### Addendum No. M-04

Reference: Added Scope and clarification

Issue Date: November 18, 2024

Project: UHN TWH – SEM & Corridor (EXP Project Number MRK-23004289-A0)

**1.1.5. M-401 – LEVEL 1 FLOOR PLAN – DEMO – FIRE PROTECTION**

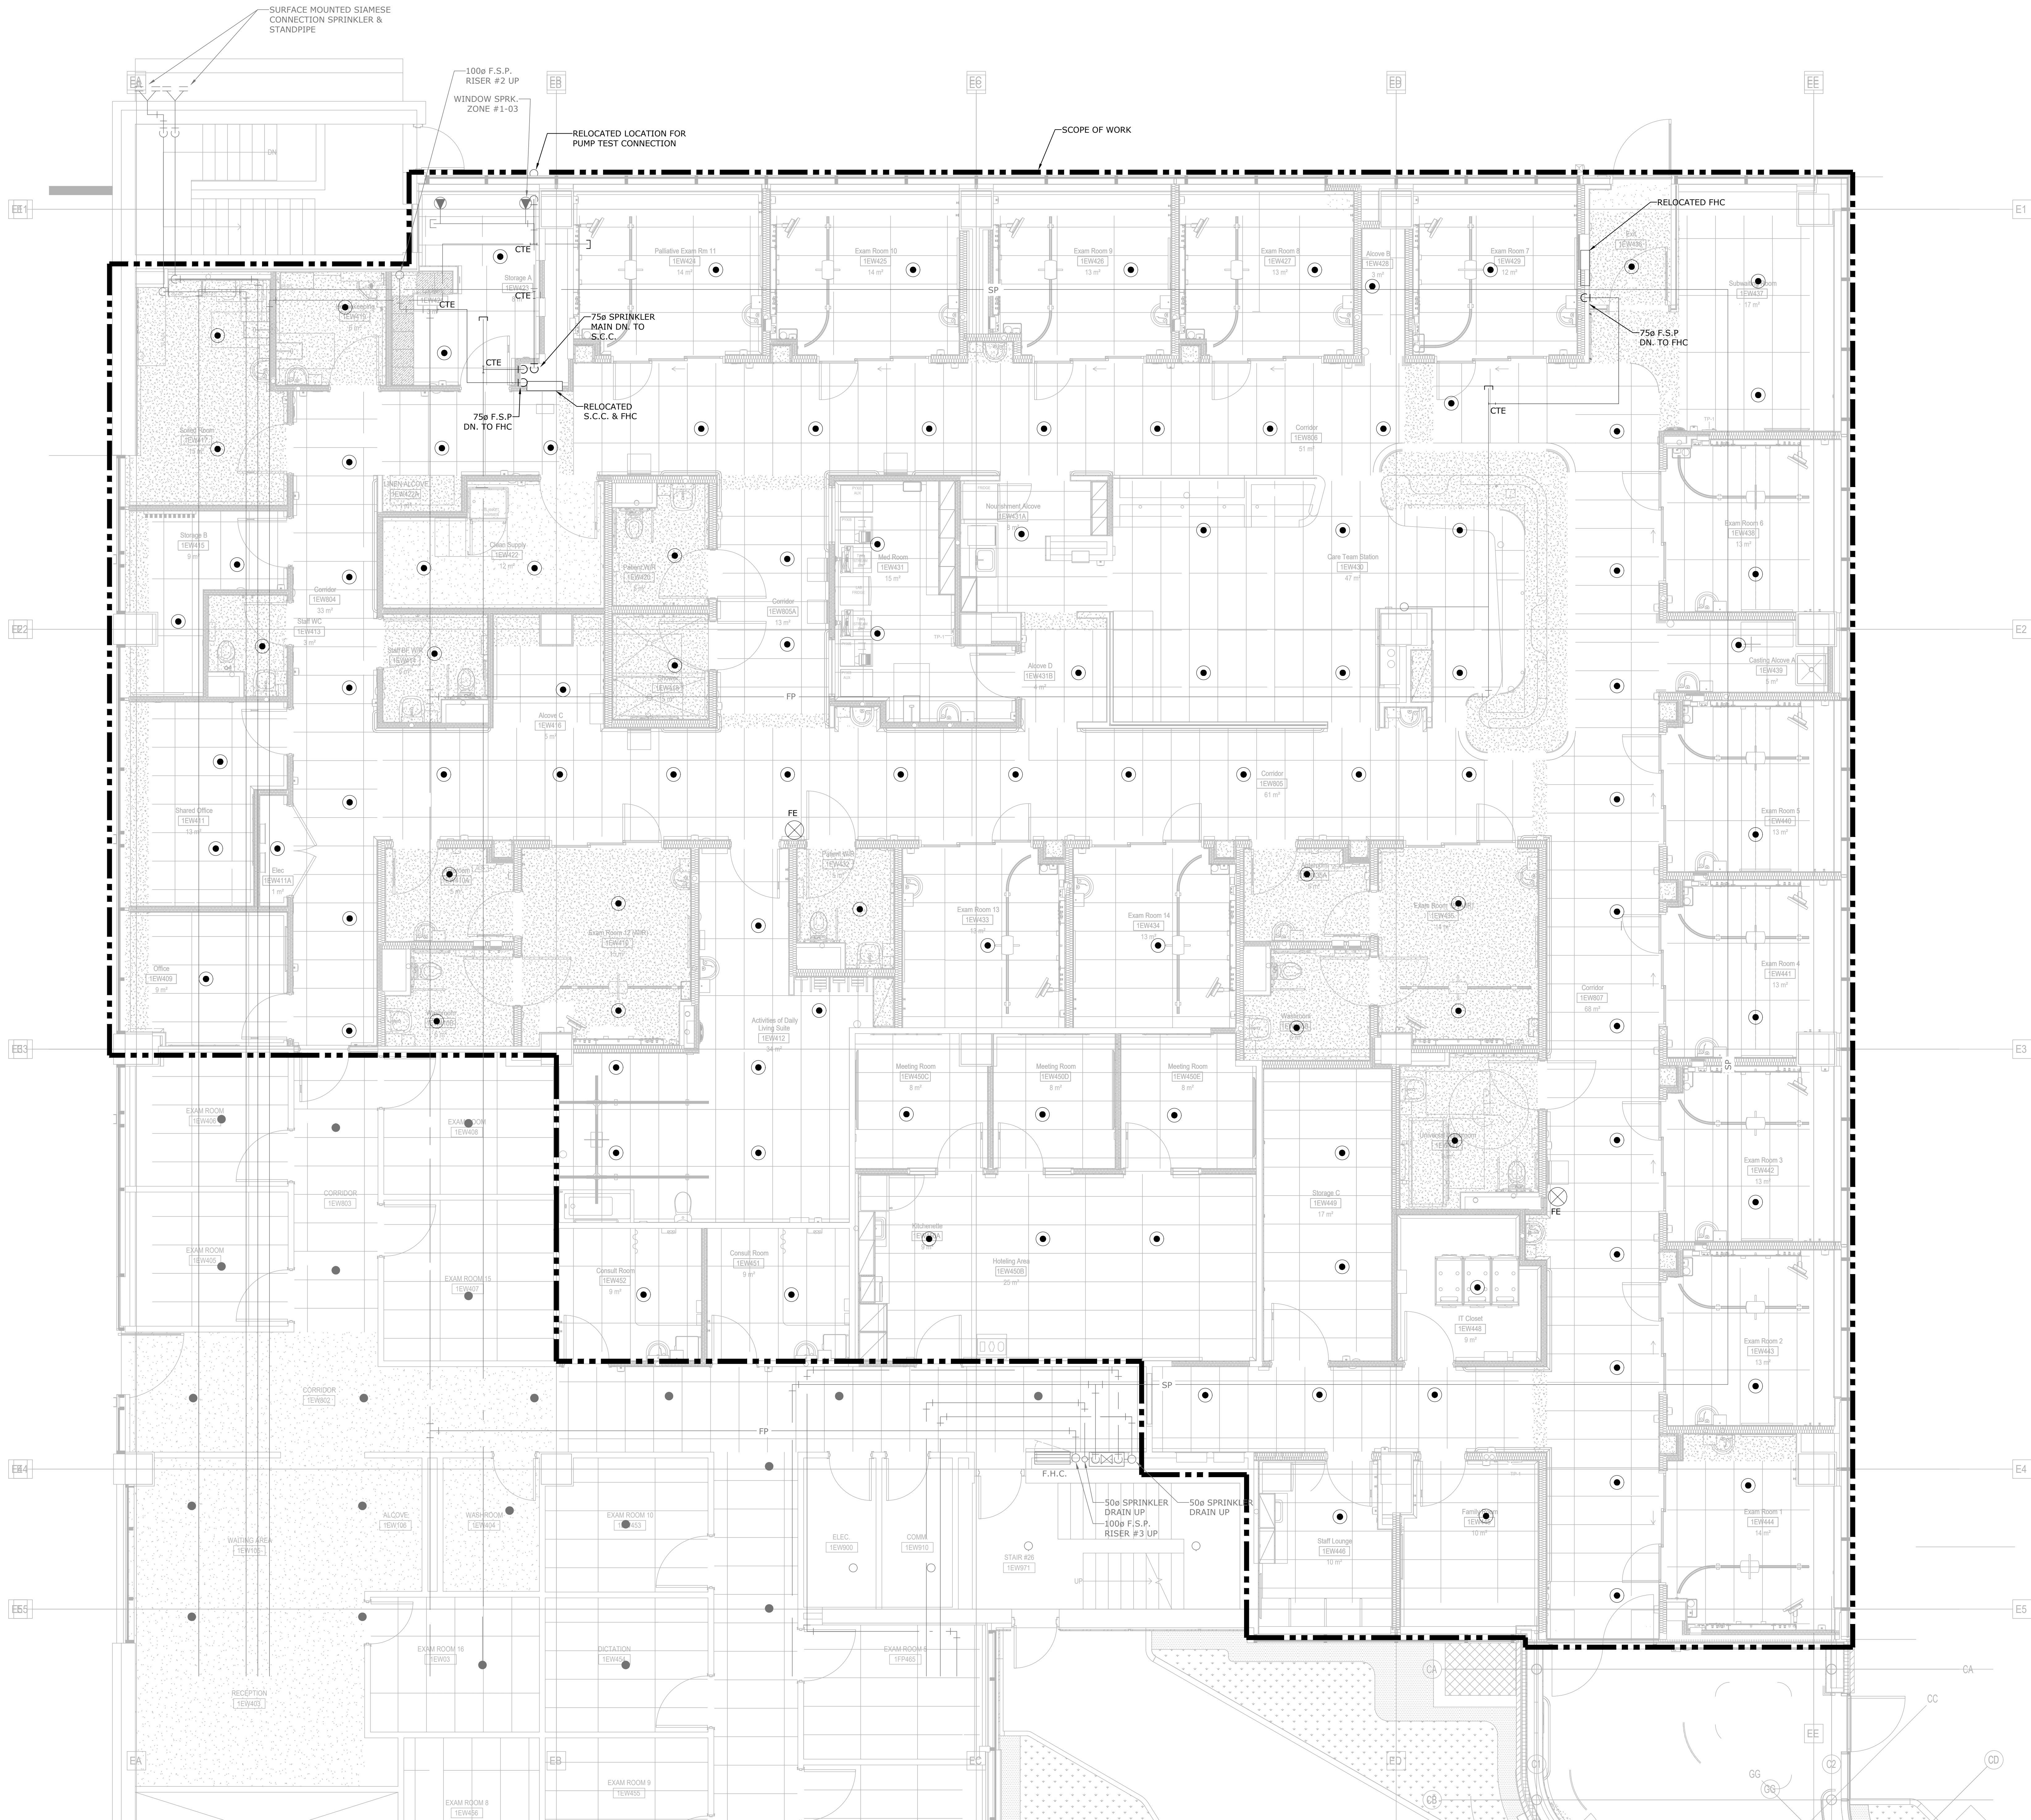
- .1 Added a tag for the surface mounted siamese connection sprinkler and standpipe.

**1.1.7. M-602 – HYDRONIC & PIPING SCHEMATIC DIAGRAMS**

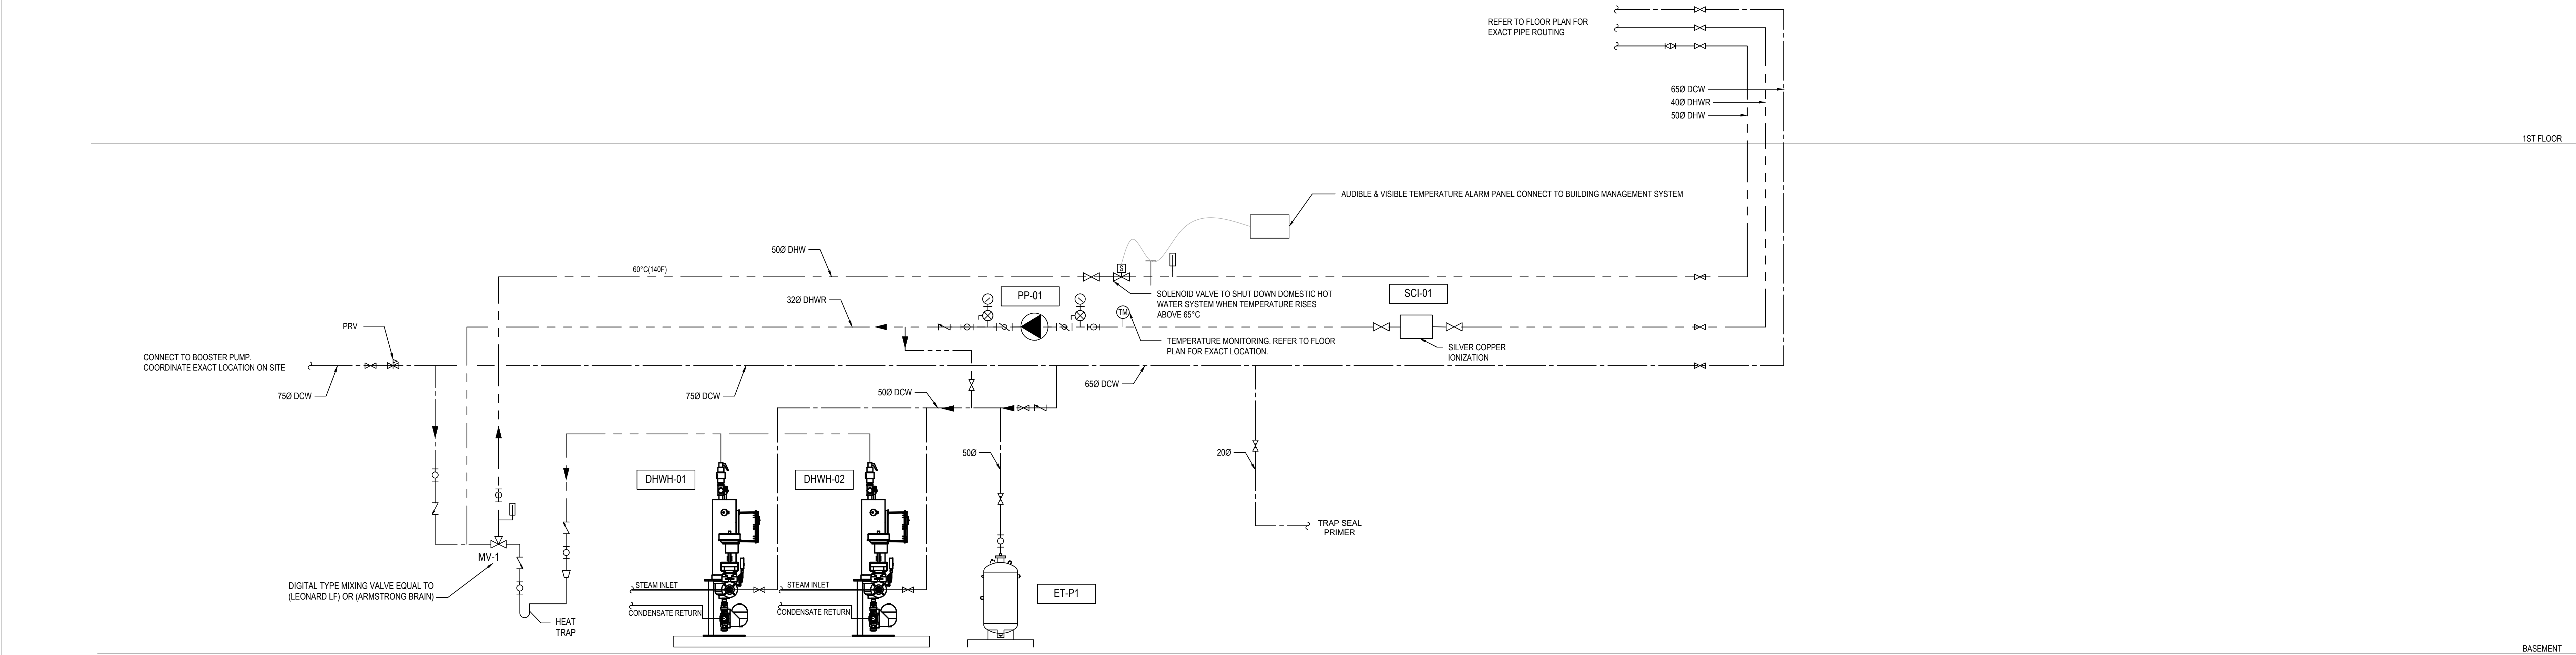
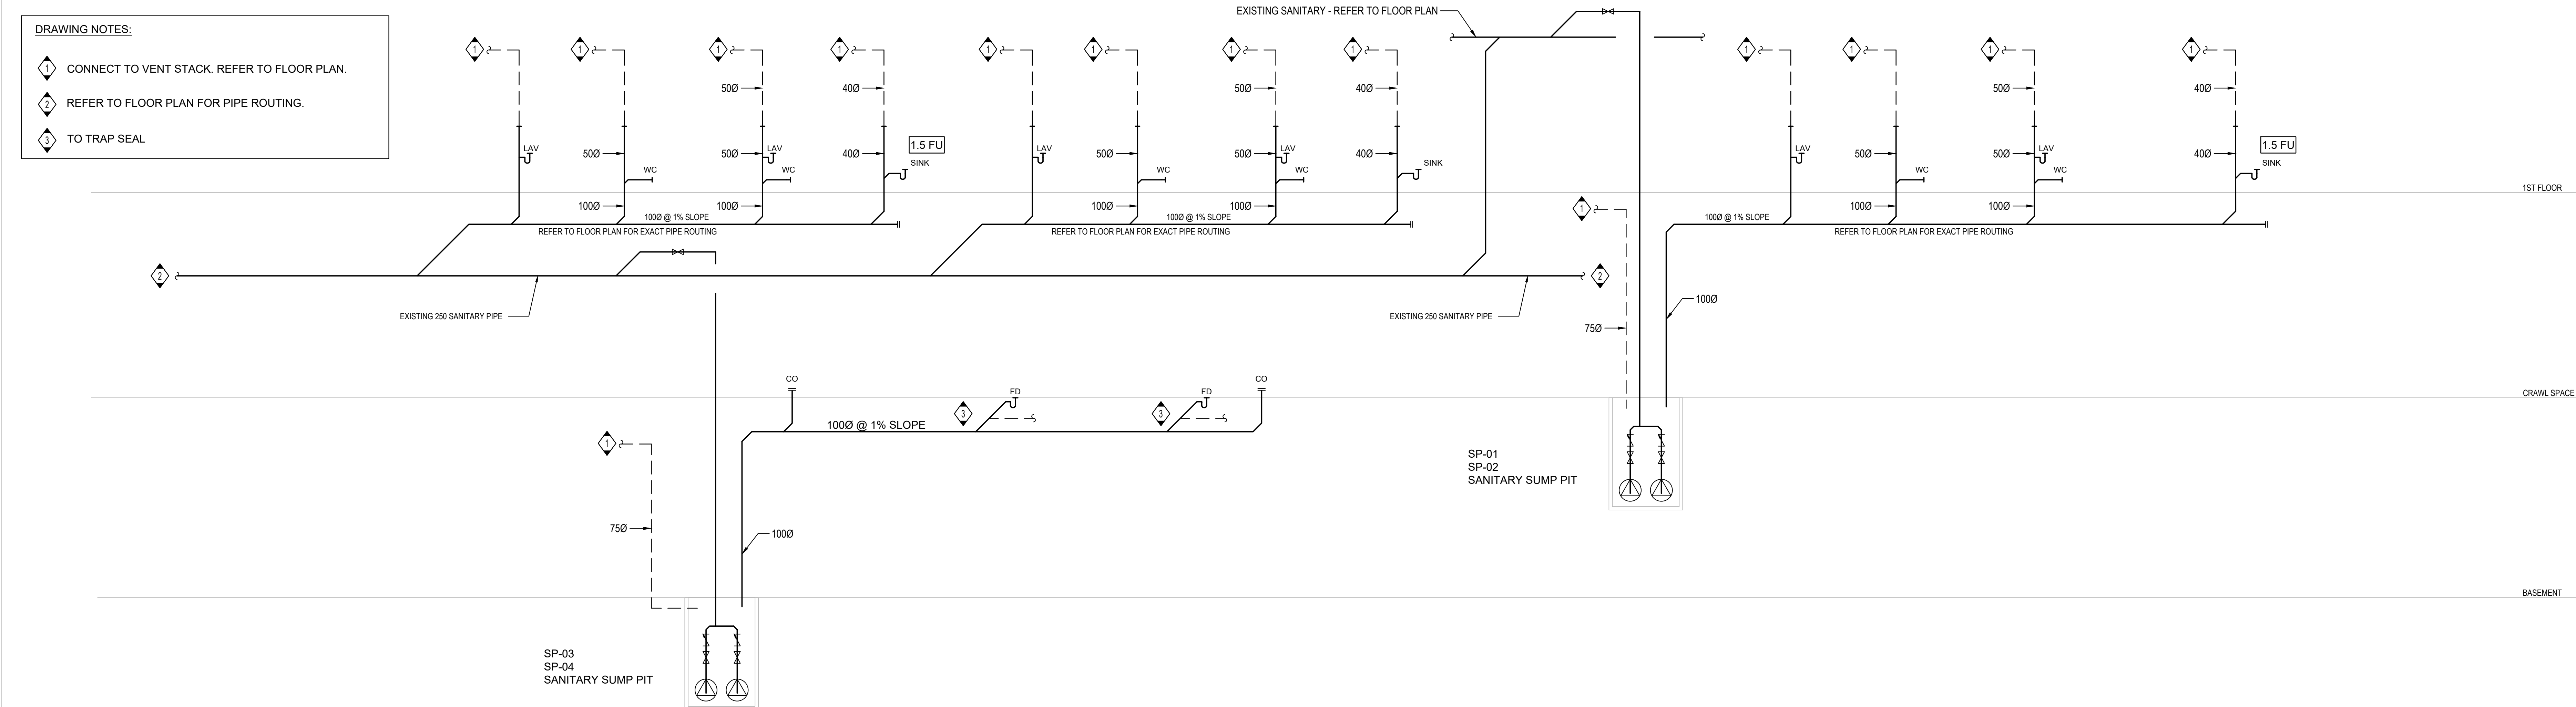
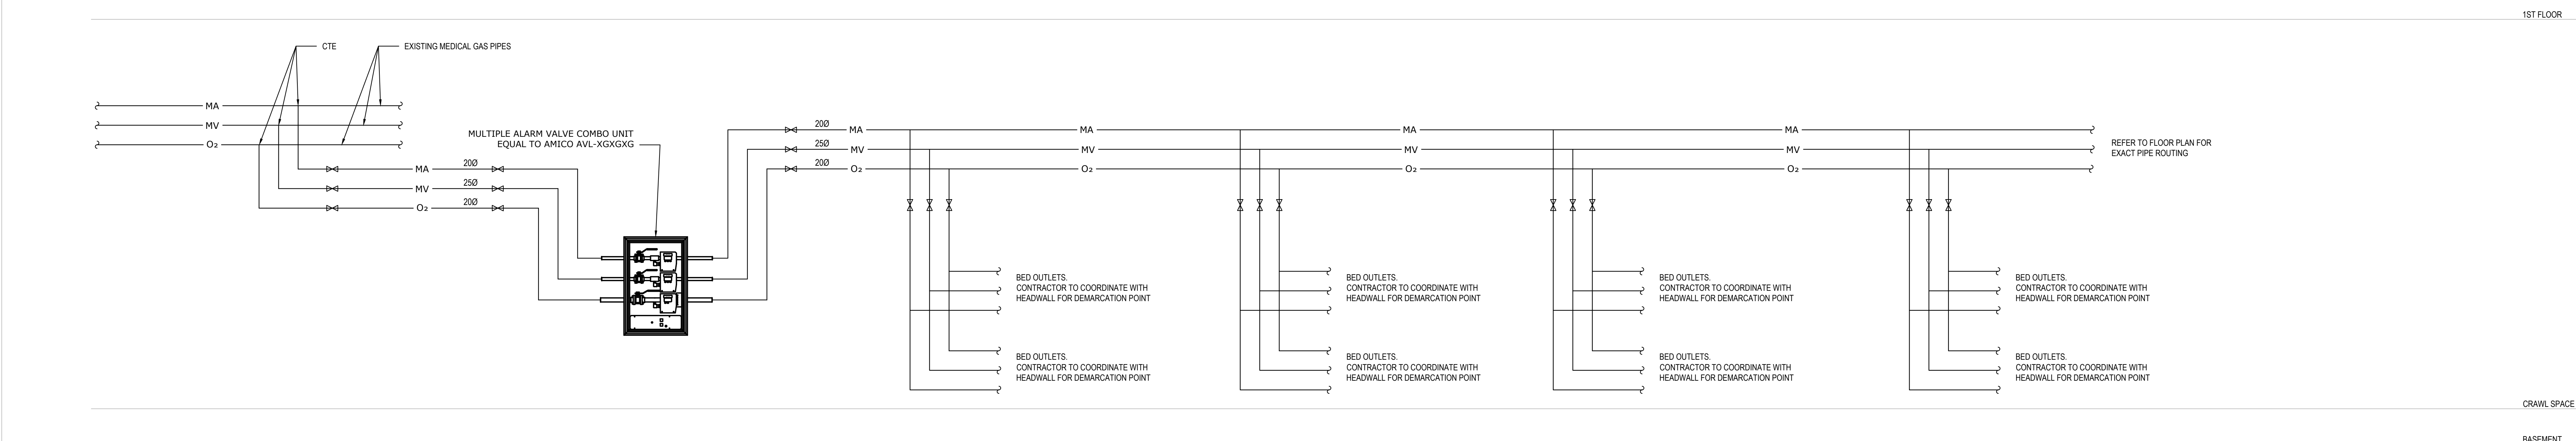
- .1 Updated the piping size to match the floor plan
